BAY LIMITED II SUBDIVISION

Engineering Comments: FINAL PLAT COMMENTS (should be addressed prior to submitting the FINAL PLAT for review and/or signature by the City Engineer):

APPLICATION NUMBER 6 DATE June 21, 2018

DETAIL SITE PLAN

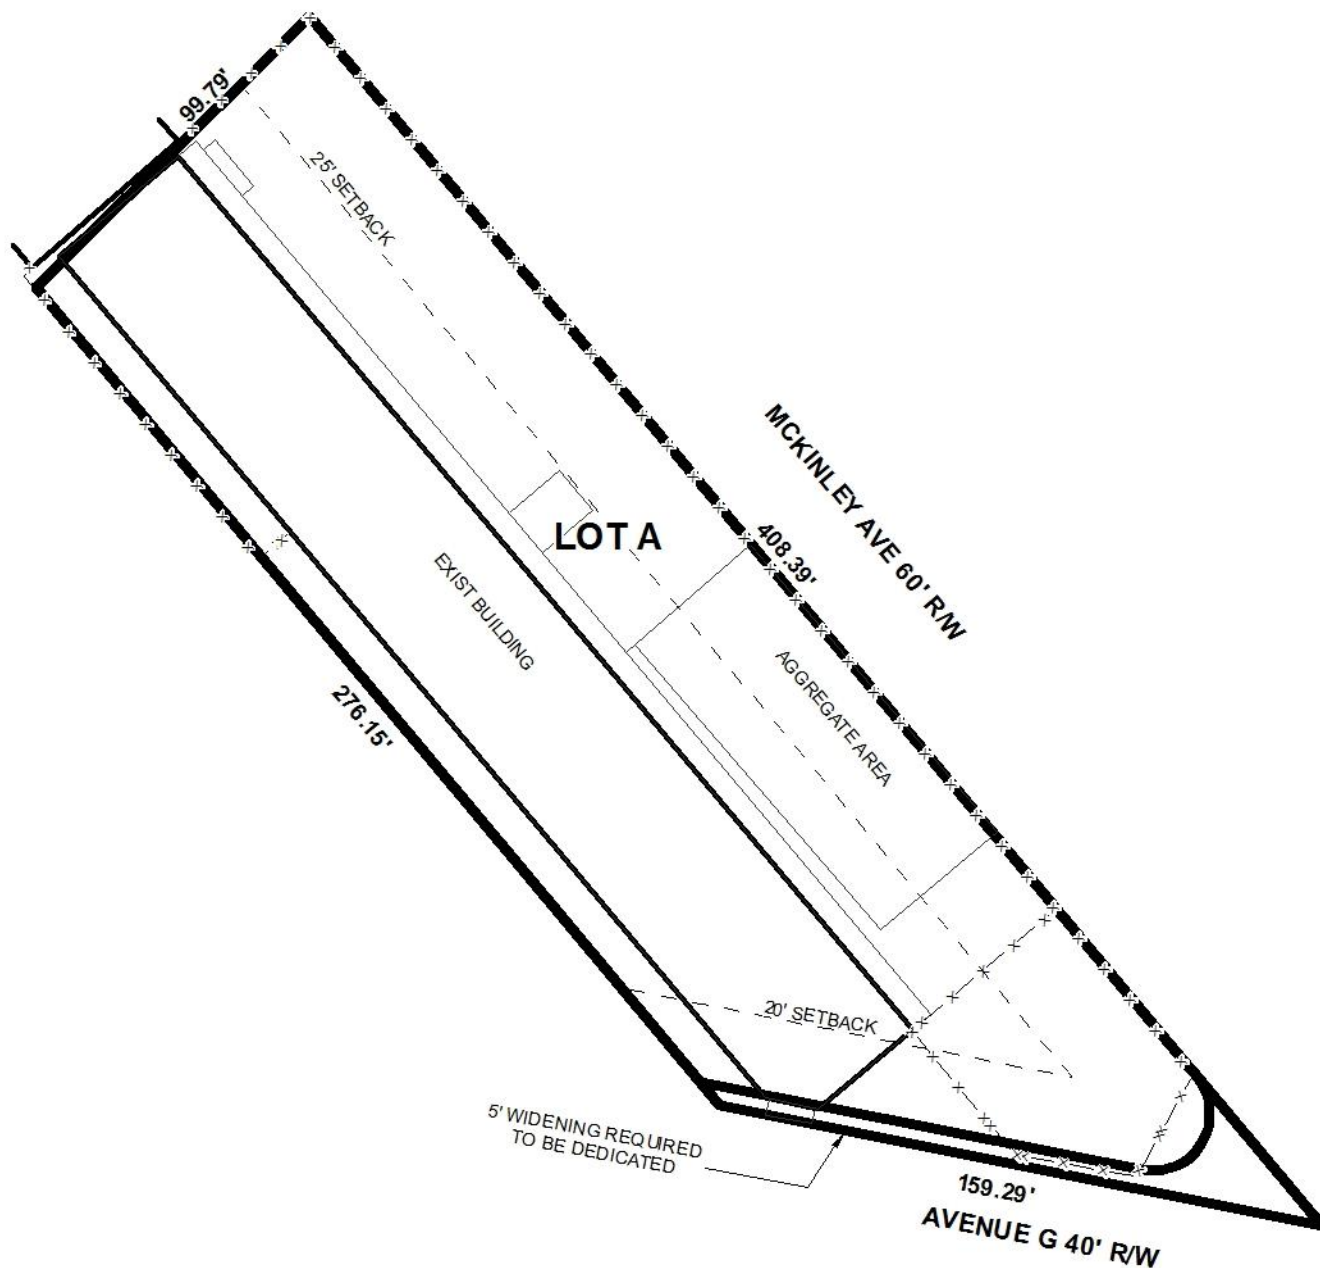
The proposed lot has frontage on McKinley Avenue and Avenue F, both minor streets without curb and gutter, each requiring 60' right-of-way widths. Adequate right-of-way is illustrated along McKinley Avenue, and dedication to provide 25' from the centerline of Avenue F is proposed, as well as the corner radius of McKinley Avenue and Avenue F. Dedication along Avenue F would result in a portion of the existing structure to be in the right-of-way. It should be noted, however, that previous approval of West Mobile Terrace Subdivision, Block 21, Resubdivision of Lots 31-50, which was heard at the November 16, 2006 meeting of the Planning Commission and is 240'± from the subject site, did not require any additional dedication along Avenue F and, as such, no additional dedication should be required of this application. It should also be noted, however, that Avenue F is incorrectly labeled on the preliminary plat and vicinity map as "Avenue G." As such, revision of the plat and vicinity map to correctly identify Avenue F should be required, if approved.

The preliminary plat illustrates the 25' minimum building setback line along McKinley Avenue and the 20' Side Street, Side Yard setback along Avenue F. As mentioned previously, the

dedication depicted on the plat would result in a portion of the existing structure in the right-of-way, therefore a 25' setback should be depicted in lieu of dedication.

It should be noted that the site was developed with a building prior to its annexation as part of the West Mobile Annexation of 2008. The building encroaches within the 20' Side Street, Side Yard setback, but such an encroachment may be considered non-conforming.

Finally, it should be noted that the preliminary plat provided does not contain signature blocks for the property owner(s) or for those responsible for its review. As such, the plat should be revised to include signature blocks for the property owner(s), and for the Planning and Zoning, City Engineering, and City Traffic Engineering departments.

- 1) revision of the plat and vicinity map to correctly identify Avenue F;
- 2) placement of a note on the Final Plat stating the lot is limited to its existing curb cuts, with any changes in their sizes, locations or designs to be approved by Traffic Engineering and conform to AASHTO standards;

- 3) retention of the corner radius dedication at McKinley Avenue and Avenue F;
- 4) retention of the 25' minimum building setback along McKinley Avenue;

- 5) illustration of a 25' Side Street Side Yard setback along Avenue F, in lieu of dedication;
- 6) retention of the lot's size labeled in square feet and acres on the Final Plat, or provision of a table providing the same information on the Final Plat;

- 7) provision of signature blocks for the property owner(s), and for the Planning and Zoning, City Engineering, and City Traffic Engineering departments;
